**FEDERAL COMMUNICATIONS COMMISSION**

Re: Bott Communications, Inc.  
WCRT(AM), Donelson, TN  
Facility Identification Number: 25031  
File Number: BP-20100126AEA

This letter refers to the above-captioned application for a minor modification of station WCRT, Donelson, Tennessee to increase daytime antenna input power.

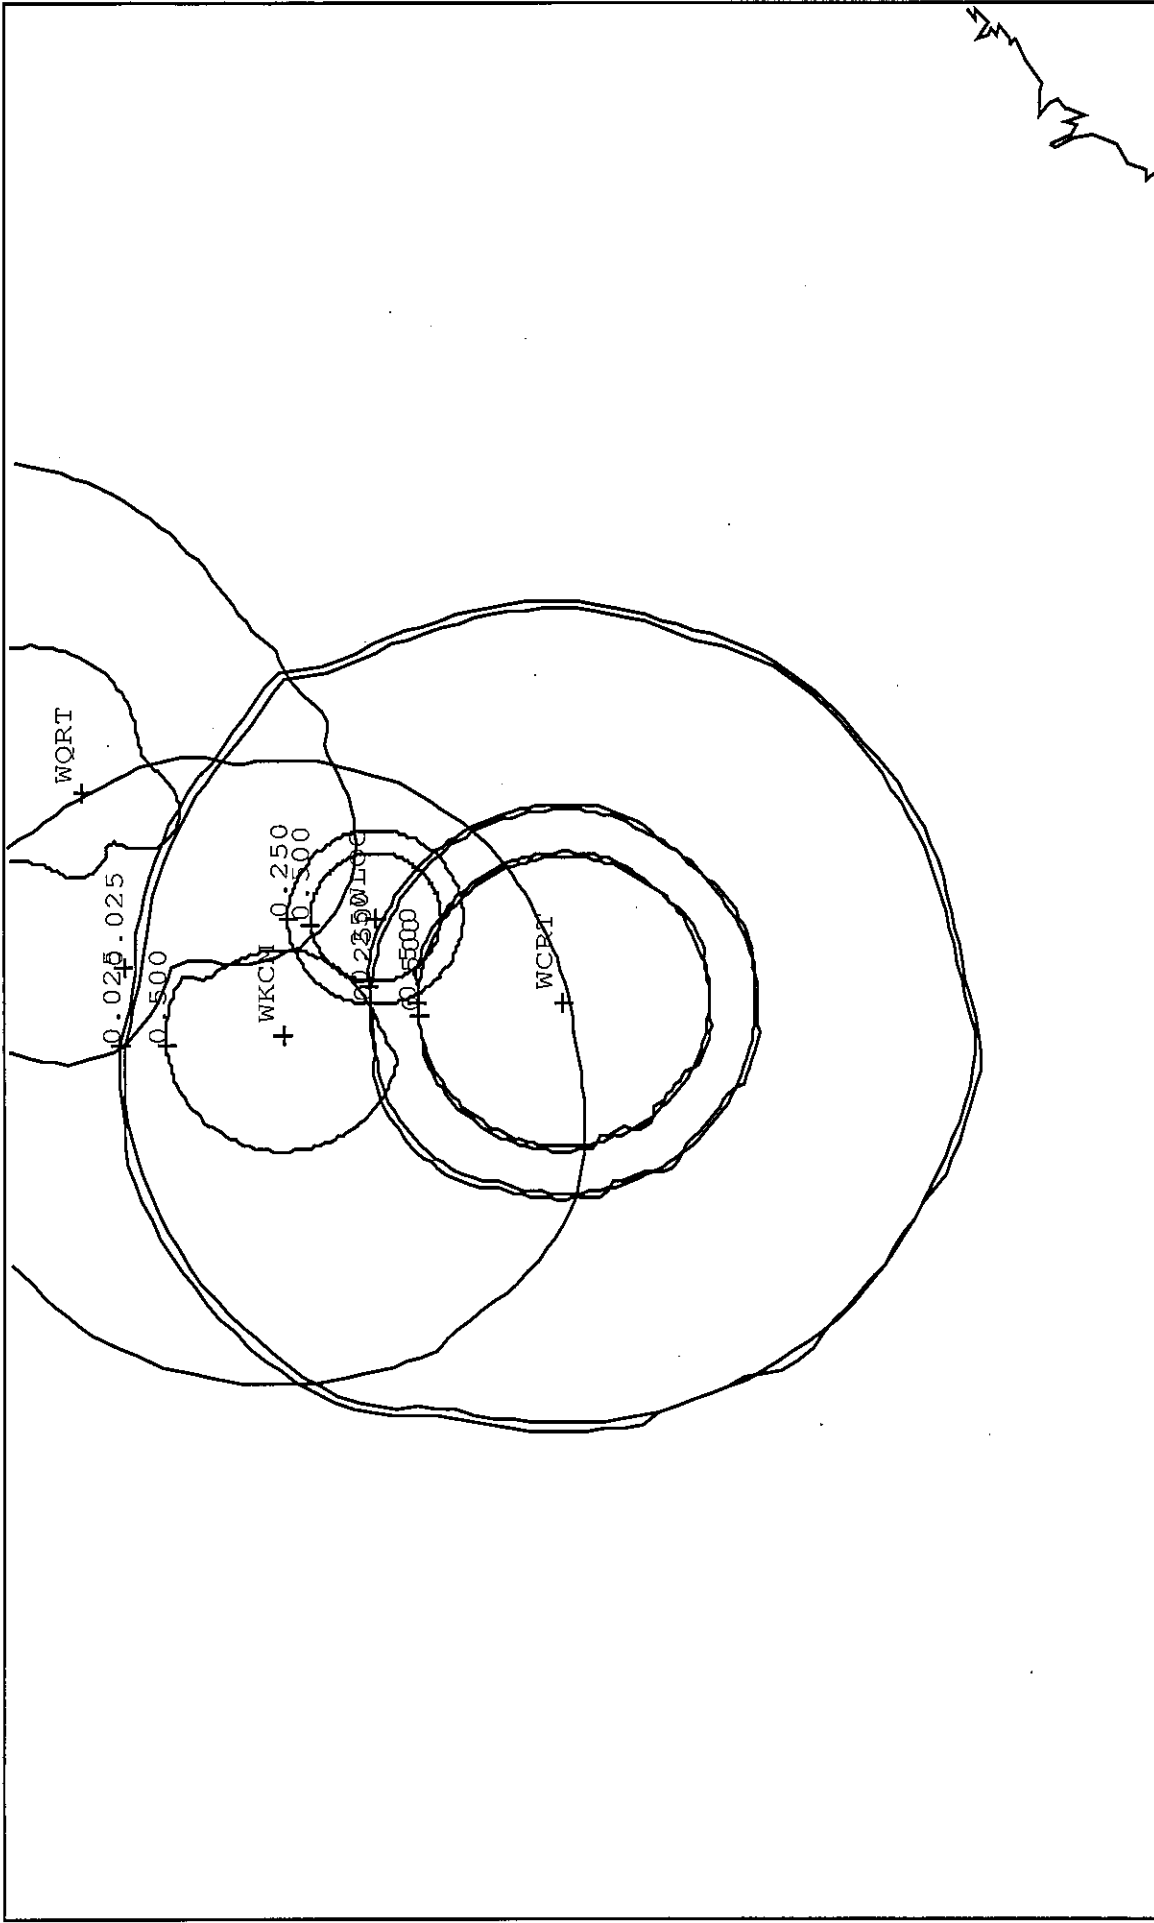
An engineering review of the application reveals that the proposed daytime operation would increase groundwave contours overlap to co-channel stations WKCM(AM), Hawesville, Kentucky, WQRT(AM), Florence, Kentucky, and first-adjacent channel station WLOC(AM), Munfordville, Kentucky, in violation of 47 CFR § 73.37(a). (See attached exhibit).

Accordingly, further action on the subject application will be withheld for a period of thirty (30) days from the date of this letter to provide you an opportunity to submit an amendment. Failure to amend or respond within this time period will result in the dismissal of the application pursuant to Section 73.3568. Please note that any amendment must be submitted in the same manner as the original application.
